DEVELOPMENT REVIEW COMMITTEE (DRC) COMMENT REPORT

PROJECT NAME: Huizenga Park Restaurant

CASE NUMBER: UDP-S23056

REQUEST: Site Plan Level II Review: Huizenga Park 12,688 Square-Foot of Restaurant Use with 5,846 Square-Foot of Outdoor Dining

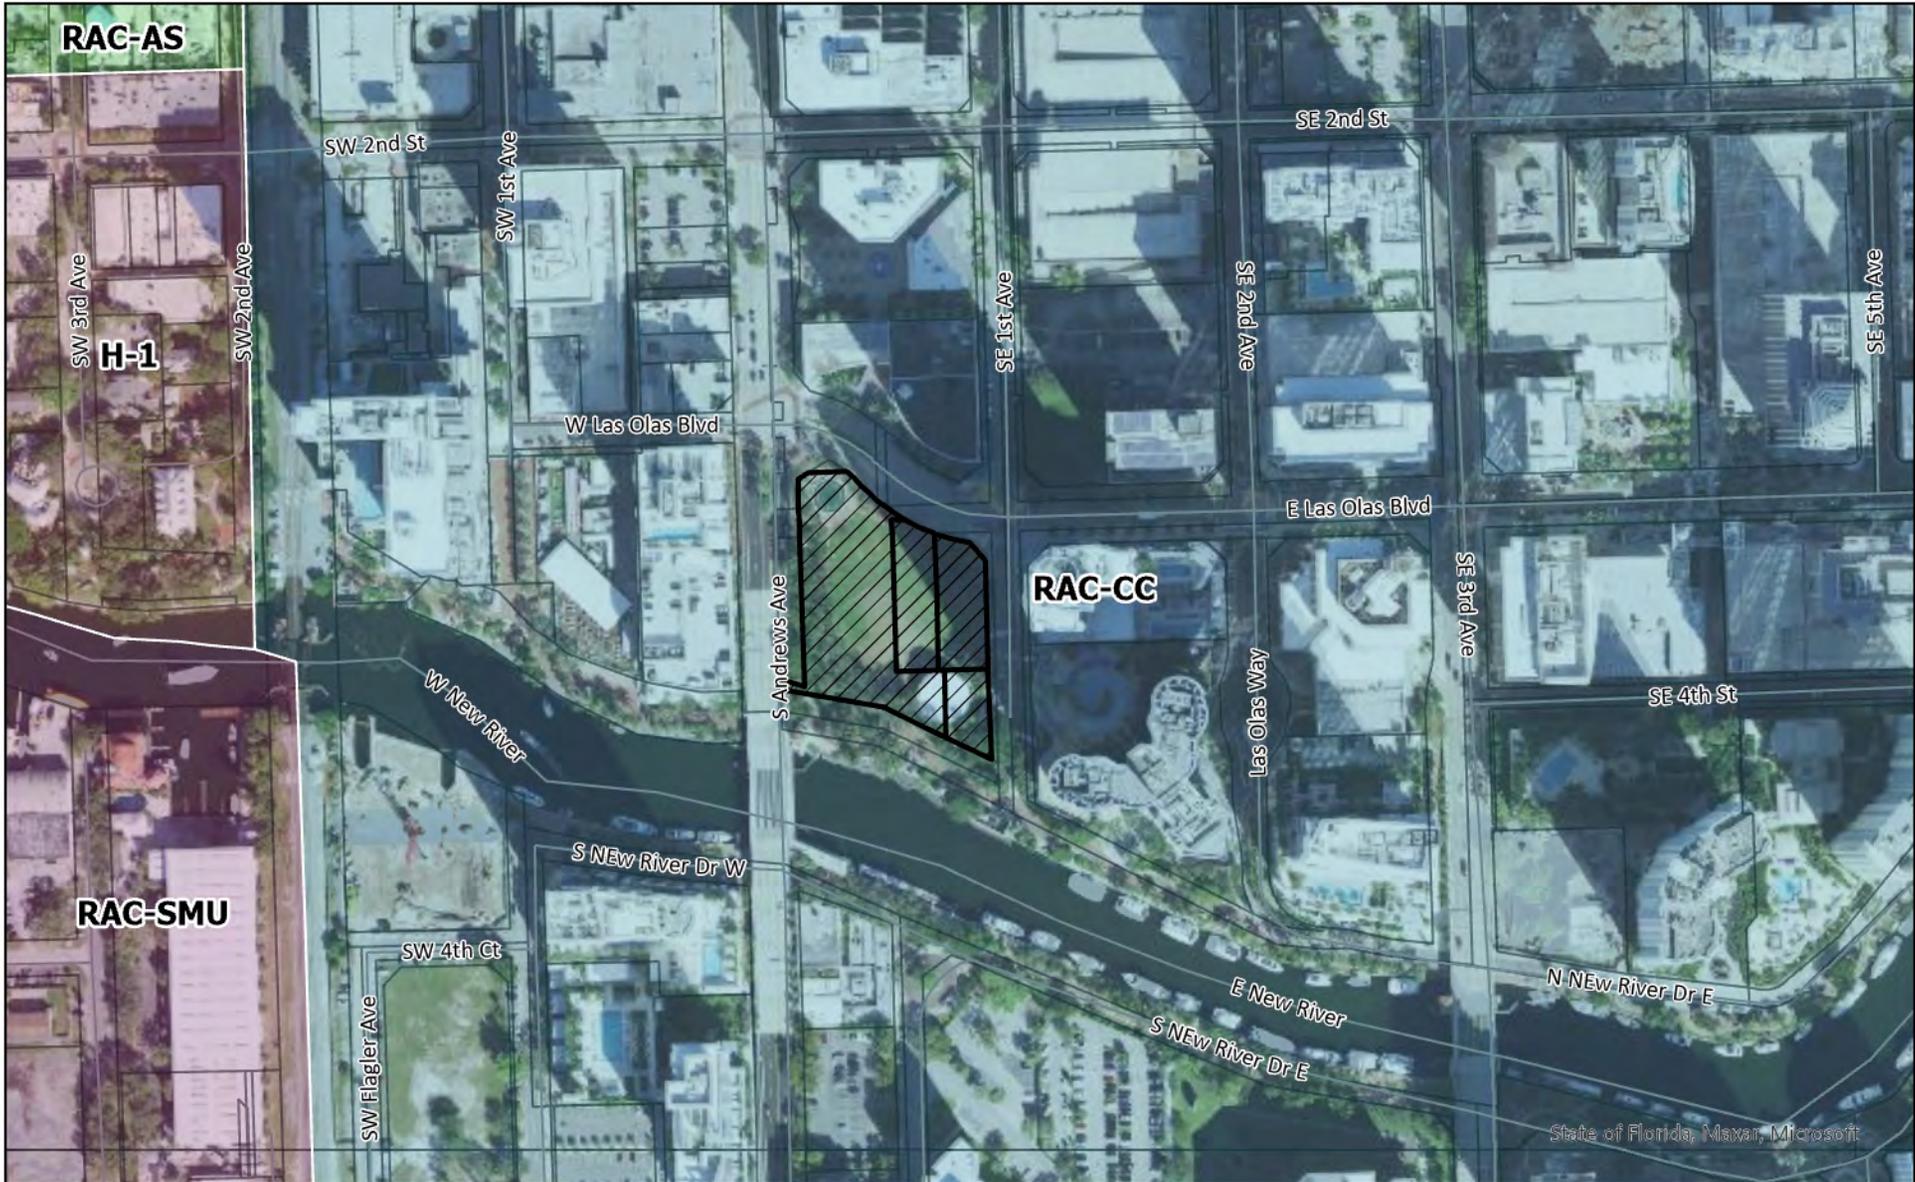
18. The project does not meet certain Downtown Master Plan (DMP) design intents as outlined in ULDR, Section 47-13.20 and Section 47-13.21, respectively. Staff has commented below under the applicable category and has provided images to assist the applicant.

- a. SF-3, Encourage durable materials for ground floor retail and cultural use.
- b. SF-4, Encourage 15-foot minimum floor-to-floor height and encourage interior ground floor flush with adjacent public sidewalk.
- c. SF-5, Encourage significant glass coverage for transparency and views. Encourage restaurants to provide clear visual and physical connections to outdoor seating.
- d. SF-6, Encourage pedestrian shading devices of various types (min 5-foot depth). Provide more information as to how this is being achieved.
